TECHNICAL BULLETIN

TX-1A - TX-1B COLORPLEXERS

BULLETIN #3

SUBJECT: Suggested modifications for improved performance of the TX-1A and TX-1B colorplexers.

FIGURE 2A SCHEMATIC DIAGRAM

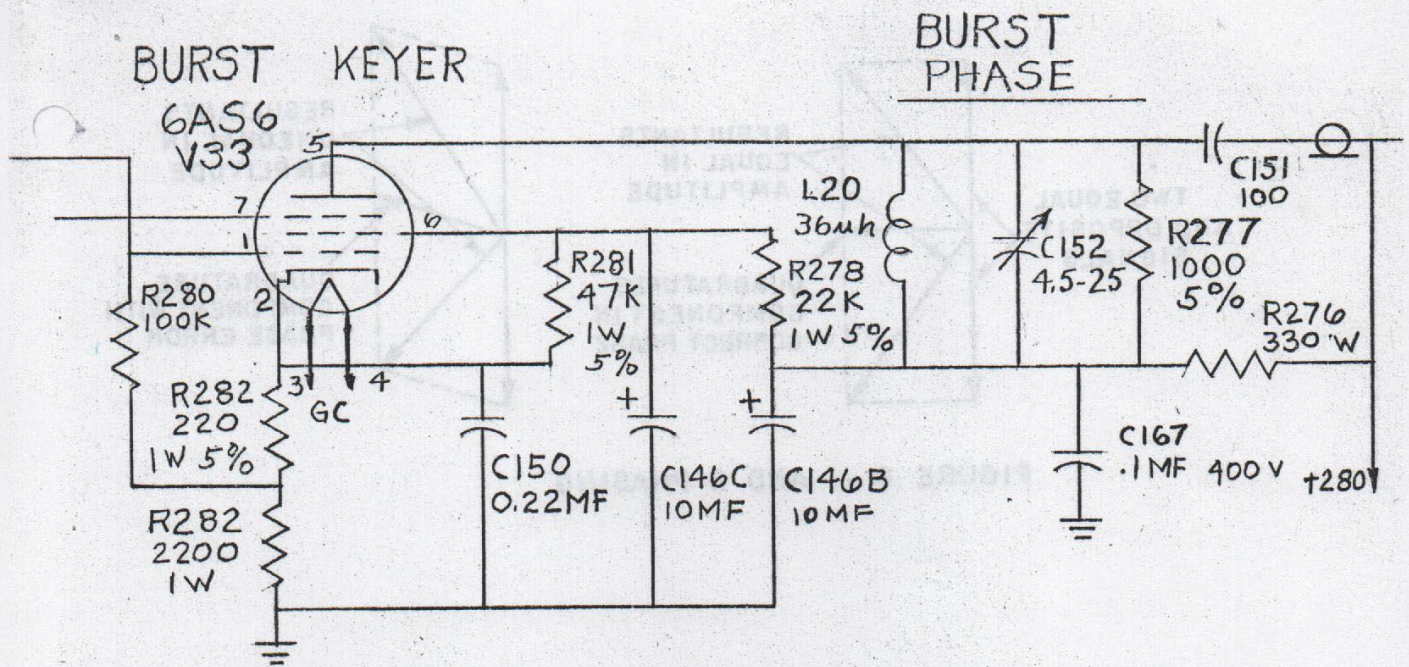
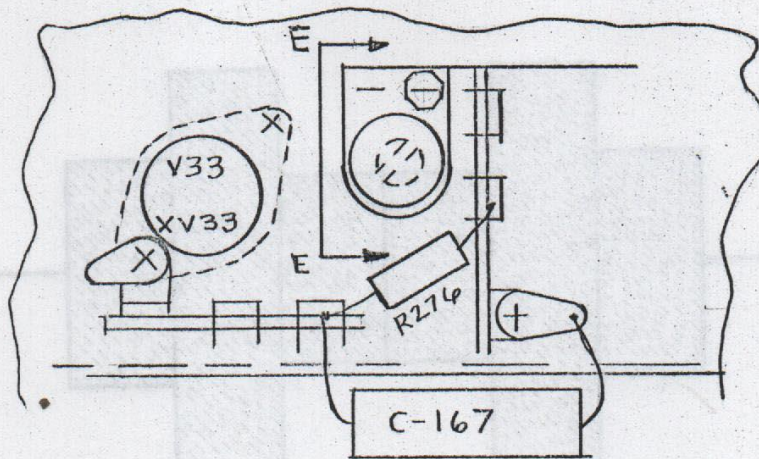
III - Prevention of Sub-carrier feed thru into the burst channel connect a 0.1 uf - 400 volt capacitor from the tube side of the 330 ohm resistor R 276 to ground in the burst gate stage (V 33). Refer to sketches 2A and 2B

THE FOLLOWING ITEMS ARE NEEDED TO MAKE THE CHANGE
 1 - #4 TERMINAL LUG (MOUNTED ON THE RIGHT HAND TERM. BOARD)
 1 - 4-40 x 5/16 MACHINE SCREW
 1 - .1 MF - 400V CAPACITOR

FIGURE 6 - I AND Q PHASING

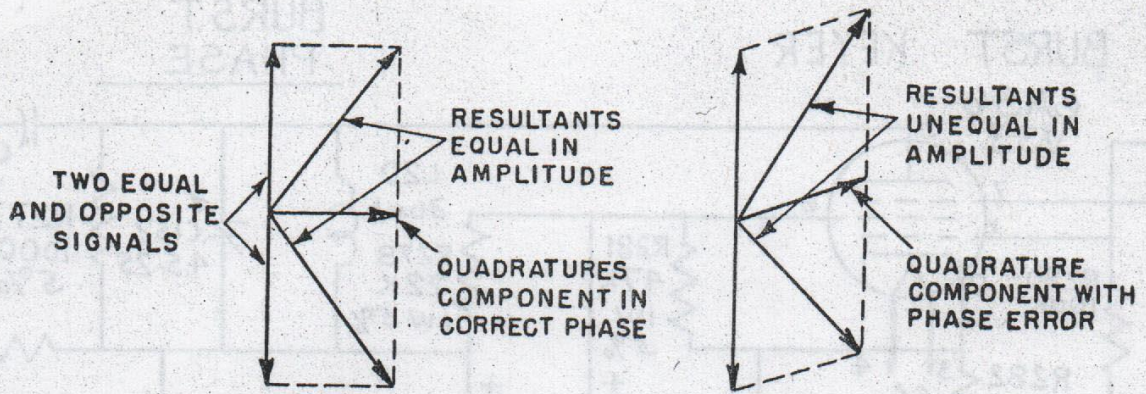
The 90-degree relationship between I and Q can be set by making use of the fact that the resultants formed by adding a 90-degree component to two signals differing in phase by 180 degrees are equal in amplitude. If the added component is not 90-degrees apart from the two signals, the resultants are not equal. The two vector diagrams shown on Figure 6 illustrate both facts.

FIGURE 7 - I MODULATED SIGNAL
CORRECTLY PHASED

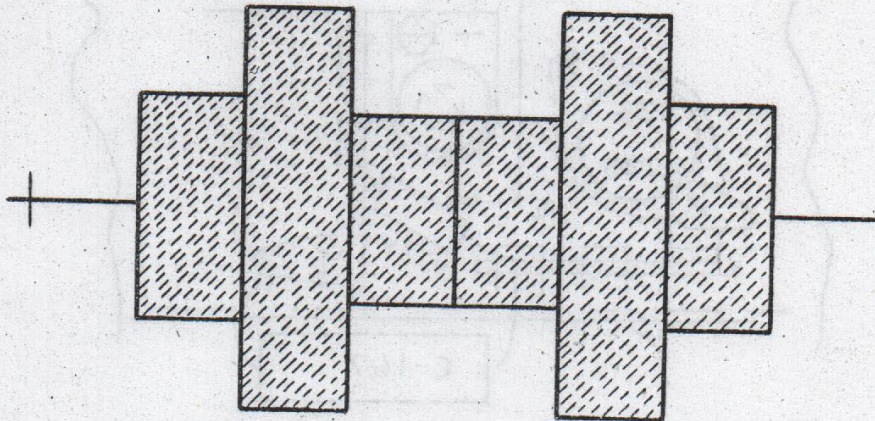
4. Switch off the M and Q channels, leaving only the I channel. In the center of this pattern, where the green and purple bar intervals are adjacent to each other, there are two signal envelopes that should be equal in amplitude but opposite in phase. See Figure 7.

With only the I signal "ON" deliberately unbalance the Q modulator (in either direction) until the carrier amplitude during the white bar interval is approximately equal to the original amplitude for the green bar. Then adjust the relative phase between I and Q (Q PHASE, C135) until the green and purple bar intervals are again equal in amplitude.

FIGURE 8 - BURST PHASING

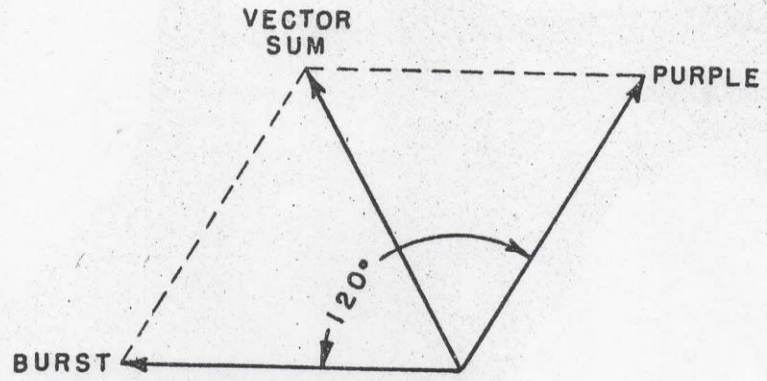
When two equal-amplitude vectors 120 degrees apart are added together, the vector sum has the same amplitude as either of the two components. See Figure 8. Therefore, the burst phase may be adjusted by making use of the fact that in a properly adjusted system, the phase of a pure purple bar interval should be approximately 120 degrees behind the phase of the burst (the exact value is 119.4 degrees, but 120 degrees is close enough).

FIGURE 9 - BURST PHASING ADJUSTMENT

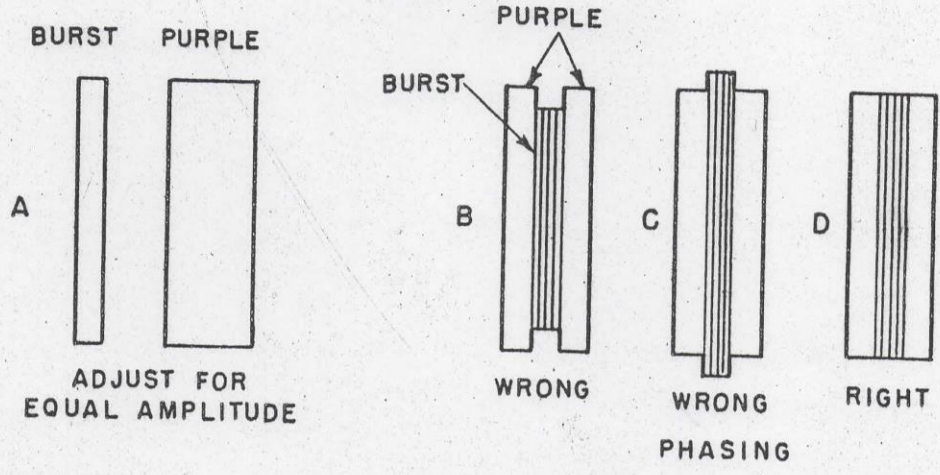
2. Adjust the burst gain so that the burst signal is equal to the amplitude of the purple signal. See Figure 9A. Then, with the "burst delay" control on the burst flag generator, move the burst into the middle of the purple bar. See Figures 9B and 9C.

3. Adjust the burst phase capacitor, C152, until the amplitude during the "purple-plus-burst" interval is the same as during the rest of the purple interval. See Figure 9D.
